**Zoning Board of Appeals
January 23, 2013 Regular Meeting**

STAFF REPORT

Subject: ZBA13-003, 515 N. Fifth

Summary: Bowers and Associates, is requesting two variances from Chapter 62 (Landscape and Screening) Section 5:603 (C):

PROPOSED LANDSCAPE PLAN
SCALE: 1/8" = 1'-0"

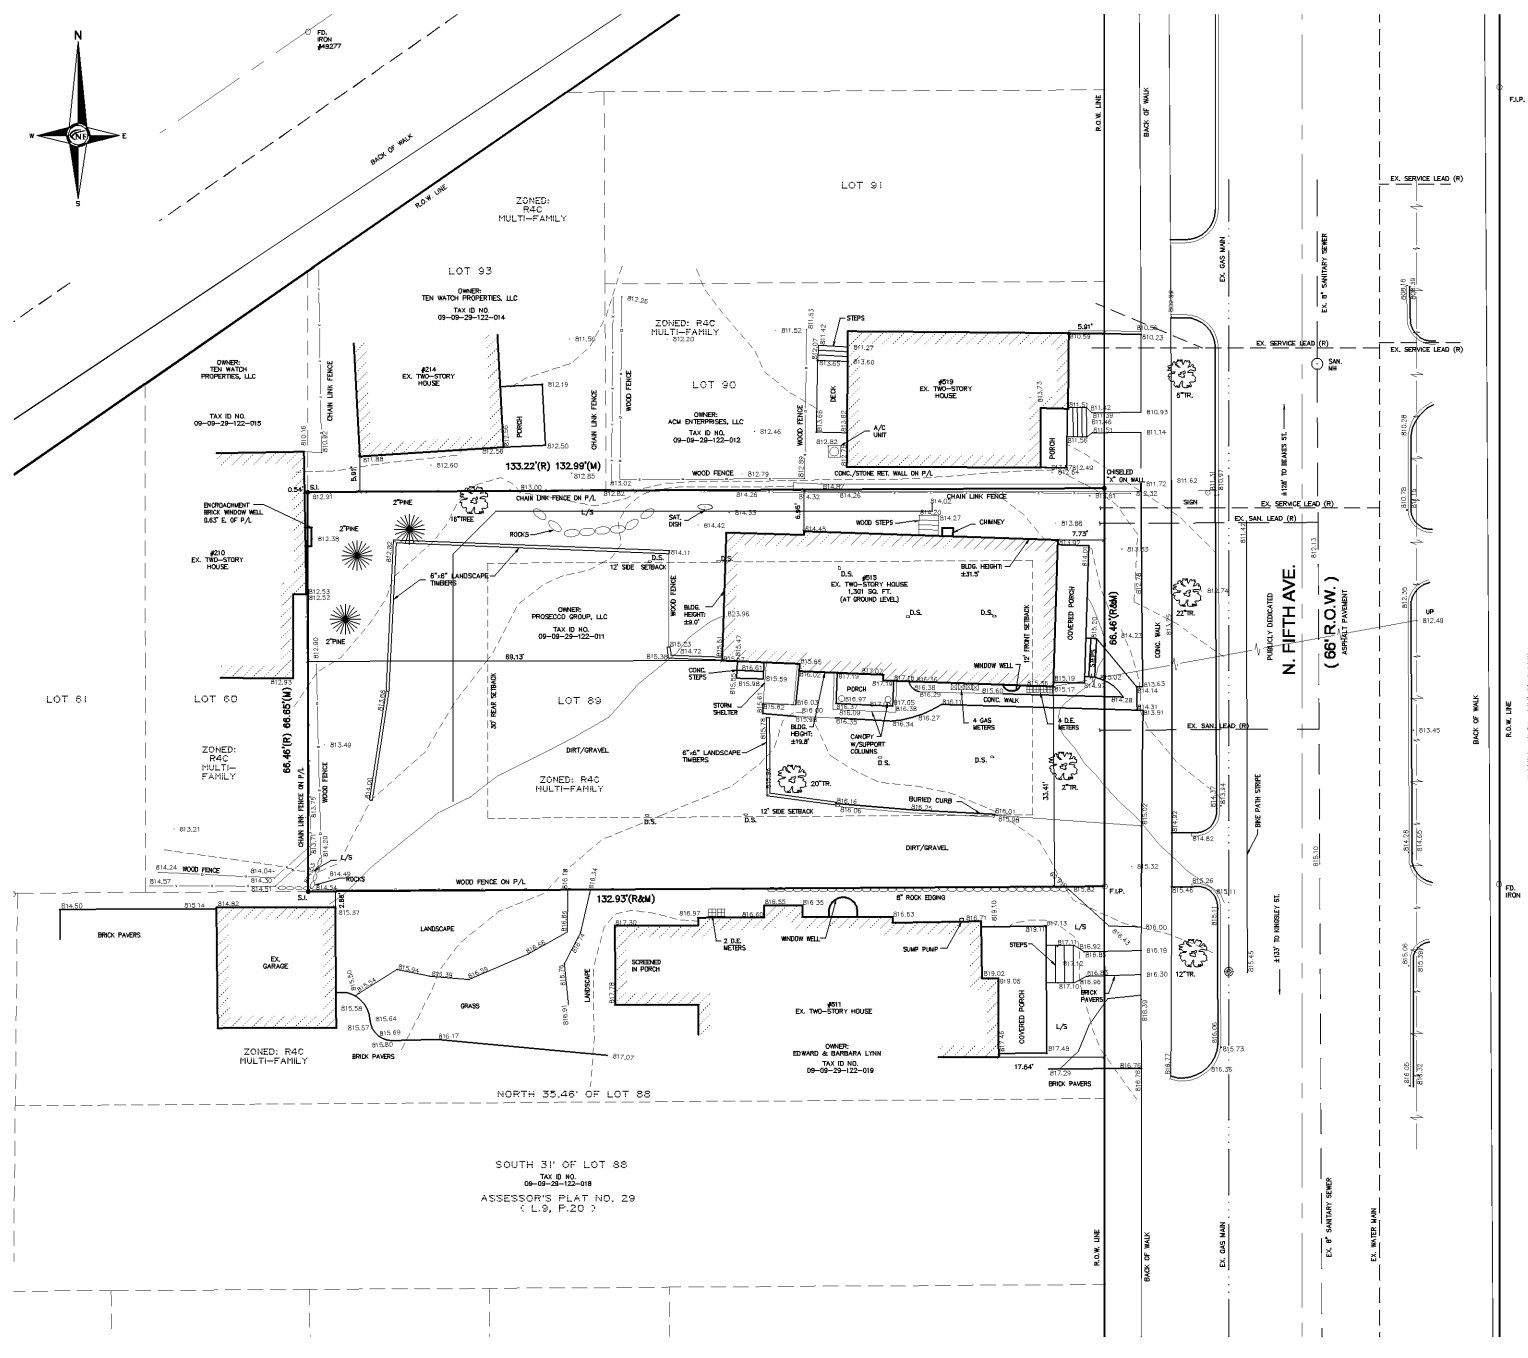
The variance for the north buffer is requested in order to reduce the required 15 foot width down to a minimum of 12 feet for 56 feet along the north property line. The length of the required buffer is 133 feet which is the depth of the parcel from North Fifth Avenue. The remaining buffer area will meet all requirements. All required landscaping will be installed in the buffer area. As permitted by code, a sidewalk leading from Fifth Avenue to the front door of one unit will be located within the buffer area.

The variance for the south buffer is requested in order to reduce the required 15 foot width down to a minimum of 1 foot for 57 feet from the front property line and 12 feet 6 inches for 42 feet along the south property line. The length of the required buffer is 133 feet which is the depth of the parcel from North Fifth Avenue. A total of nine trees are required to be planted within the buffer. The petitioner is proposing to plant 4 trees, 5 less than required. The remaining buffer area will meet all requirements. A driveway leading to the enclosed 4 car garage will be located 2 feet from the south property line for the first 57 feet from the front. Although not required, a five foot high fence will be installed along the length of the southern property line to help mitigate for the reduced buffer. All required parking for the proposed development will be enclosed and not visible to the south.

The properties to the north will have the intent of the CLUB met with 15' buffer for 77' of the property and a 12' buffer for the balance of the property - 56' of length. The required plantings and a wood fence are provided.

The neighbors to the south understand and agree with the request for variance for the CLUB. We are providing 12'-6" buffer for 42.93' of the property line with required plantings. A wood fence exists. We propose to extend the fence to screen the vehicular use area – from the property to the south.
- 4. What physical characteristics of your property in terms of size, shape, location or topography prevent you from using it in a way that is consistent with the ordinance?**
